RE: Meeting Notes for Traffic Response to Incomplete Letter for Bay Area Vipassana Center

On November 4th, 2020 Brian McNamara and I, from the project team, met with Leo Comacho and Gavin Finley from Roads and Airports to discuss the incomplete letter that Santa Clara County issued for the Bar Area Vipassana Center located just outside of Gilroy. Specifically, we discussed items 9, 37, 38, 39, 40, 41, 42 and 43 from the incomplete letter. Brian McNamara also provided an exhibit to help staff better understand the operations of the proposed center that I have included as an attachment to this letter.

Proposed parking spaces higher than other centers as a ratio to max capacity

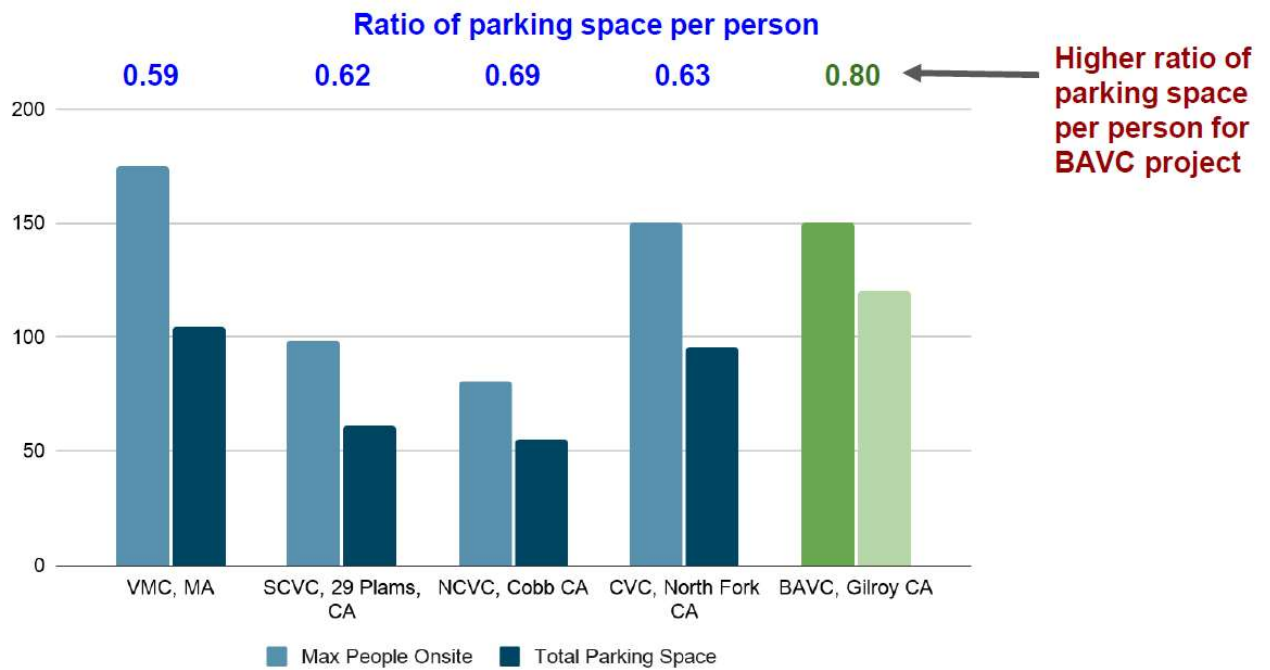
9. Parking: Staff has concerns regarding the methodology of parking assessment. Staff will conduct a peer-review of the parking study in order to determine the best methodology for the parking suitable for the proposed use. A parking space per unit requirement may be more suitable to the proposed use.

Since the original submittal, the project team has been working on the site plan to address concerns. The original submittal included 95 total parking spaces and the new proposal will include 121 parking spaces. This will increase the ratio of spaces per maximum persons on site to 0.80. To contrast this ratio, we looked at the other three Vipassana retreat center locations in California and one in Massachusetts that are all currently operating without parking shortages. The ratios ranged from 0.59 to 0.69 spaces per person on site, much less than what is currently proposed. Attached is graph that depicts the results as well. It is my professional opinion that the parking proposed will more than adequately meet the demand and is also well supported in the original findings backed by the Institute of Transportation Engineer's (ITE) *Parking Generation Manual, 4th Edition*.
